**TII Response to Hampstead Residents' CLG Submission (made  
on 21 February 2024)**

### **Hampstead Residents CLG. (Ref: - Submission No 111/Case 314724)**

**Our submissions at An Bord Pleanala (ABP) Metrolink Oral hearing 21/2/24.**

**Figure 15: Page 61 of the Preferred Route Public Consultation Report 2019**

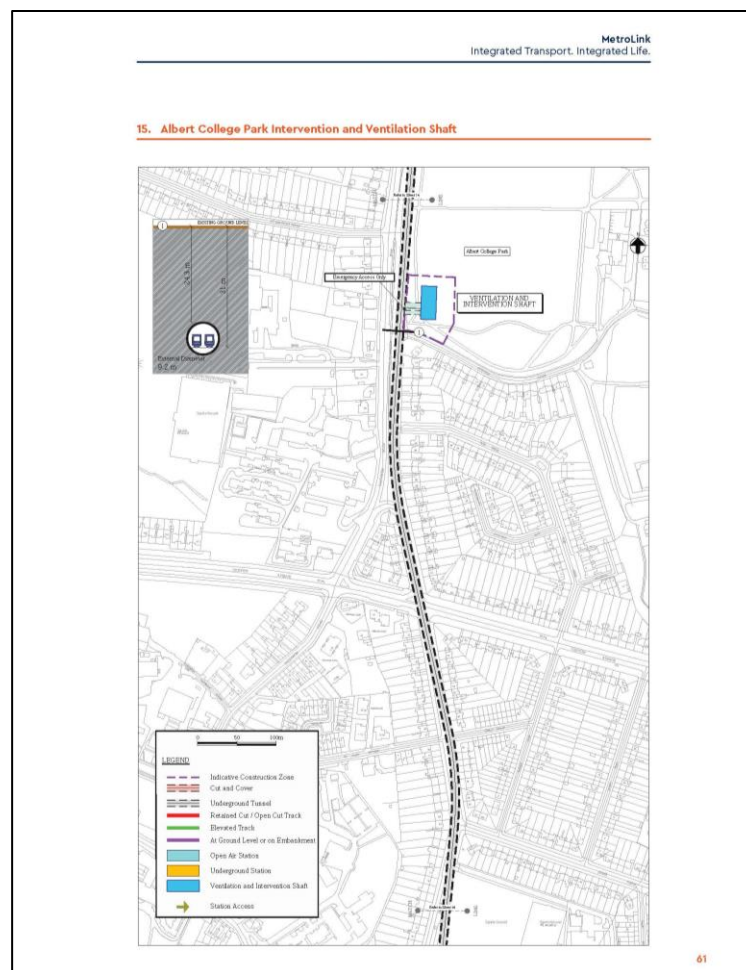
Our important point here is that 2 days before closure of the consultation phase (Emerging Preferred Route ‘consultation’ March-May 2019), there emerged from TII, new but critical **tunnelling/excavation** information. This was a ‘hand drawn sketch’ of a proposed intervention shaft, located in the South West corner of Albert College Park, meters away from our residential area. :-

The importance of the 'sketch' of the proposed **excavation** in the Park was huge for our residents. It outlined, a large construction site on our doorstep, with NO associated local benefits for our residents or the wider community. We ask the inspector to investigate this, and the associated NO consultation.

The proposed location of the intervention shaft formed part of the information provided during the non-statutory public consultation on the Preferred Route in 2019. It was detailed in the Preferred Route Public consultation documents: Figure 15 Public consultation report and in the design development report. While it was an element of the Preferred Route design that had not been developed to the same level of detail as stations for instance, there was sufficient information to ascertain it would be located in the park.

Our records show that a notification was issued to you from our database on Tuesday, 26 March 2019 in relation to the Public Consultation on the Preferred Route.

##### **Temporary Land take proposed for Albert College Park:-**

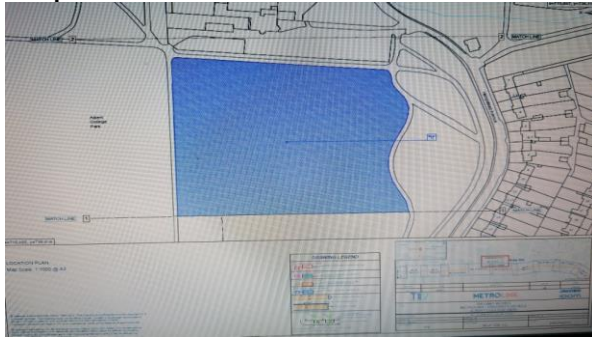
We welcome the TII/NTA clarification that the blue areas do not relate to removal of any trees or hedges, in the TII/NTA maps (Ref Map A&B item 16)and that we had attached to our submission. We acknowledge that TII/NTA have stated that no trees along the Hampstead Avenue boundary are planned to be removed (Ref:- Map A and B in item 16 below) .

However we would require that the word ‘planned’ is removed from the statement...and revised as:- “No trees along the Hampstead Avenue boundary, and the blue area (maps indicated in Item16) will be removed.” We ask the Inspector to place this condition in the RO.

We have no objection with the request to remove the word 'planned' and the statement is revised to: - *"No trees along the Hampstead Avenue boundary, and the blue area (maps indicated in Item 16), will be removed."*
